April 9, 2020

RE: Comments on the Waste Treatment and Immobilization Plant Risk Assessment permit modification

On behalf of Hanford Challenge, I am submitting these comments in response to the Waste Treatment and Immobilization Plant Risk Assessment permit modification.

Figure 5-5. Unmitigated Vulnerabilities Identified for Radiological Control and Industrial Safety and Hygiene.

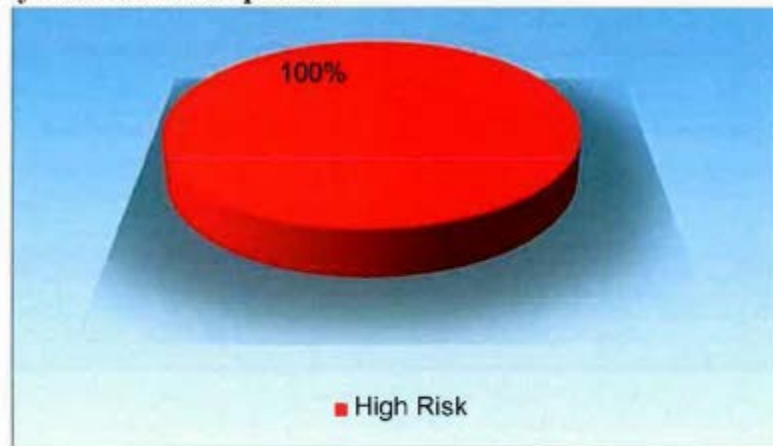
A total of eight (8) vulnerabilities were identified for the radiological control and industrial safety review area. Figure 5-5 shows that the vulnerabilities identified for the system were all considered high impact for which mitigation is recommended prior to cold commissioning and preferably prior to startup testing.

The review team identified specific issues with the radiological control approach all of which will require correction prior to startup testing. Listed below are summarized vulnerabilities:
